Access Compliance Report Public Rights-of-Way (Island Curb Cuts)

Main Street:OSO_PKWY Cross Street:ANTONIO_PKWY Location: NW

ADA ID: CCAT220208132212 Curb Cut Type:IslandRefuge3 Initial Pass/Fail: Pass Overall Compliance: No Severity Score: 50

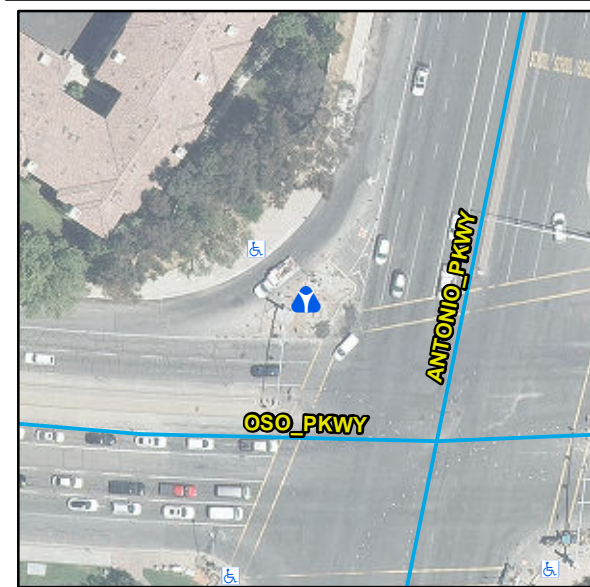
Possible Solutions:
Install Detectable Warning System. Restripe Crosswalk. Remove & Replace Gutter.

Compliance	Description	Data	Compliance	Description	Data
Yes	Refuge 1 Length (In)	64	Yes	Guttter 1 Ponding	No
Yes	Refuge 1 Width (In)	90	Yes	Gutter 1 Lip Ht (In)	0
Yes	Refuge 1 Slope (%)	4.1	No	Gutter 1 Slope (%)	5.5
Yes	Refuge 1 Cross Slope (%)	2.51	Yes	Gutter 1 Cross Slope (%)	1.8
N/A	Painted Cross Walk 1	Yes	No	DWS 1 Provided	No
	Cross Walk 1 Direction	E	N/A	DWS 1 Contrast	N/A
	Cross Walk 1 Width (In)	144	N/A	DWS 1 Length (In)	N/A
Yes	Refuge Inside Cross Walk 1	Yes	N/A	DWS 1 Full Width	N/A
	Road 1 Slope (%)	5.3	N/A	DWS 1 Offset (In)	N/A
	Road 1 Cross Slope (%)	1.73			
Yes	Refuge 2 Length (In)	64	Yes	Guttter 2 Ponding	No
Yes	Refuge 2 Width (In)	90	Yes	Gutter 2 Lip Ht (In)	0
Yes	Refuge 2 Slope (%)	3.4	Yes	Gutter 2 Slope (%)	1.9
Yes	Refuge 2 Cross Slope (%)	3.2	No	Gutter 2 Cross Slope (%)	5.2
N/A	Painted Cross Walk 2	Yes	No	DWS 2 Provided	No
	Cross Walk 2 Direction	S	N/A	DWS 2 Contrast	N/A
	Cross Walk 2 Width (In)	145	N/A	DWS 2 Length (In)	N/A
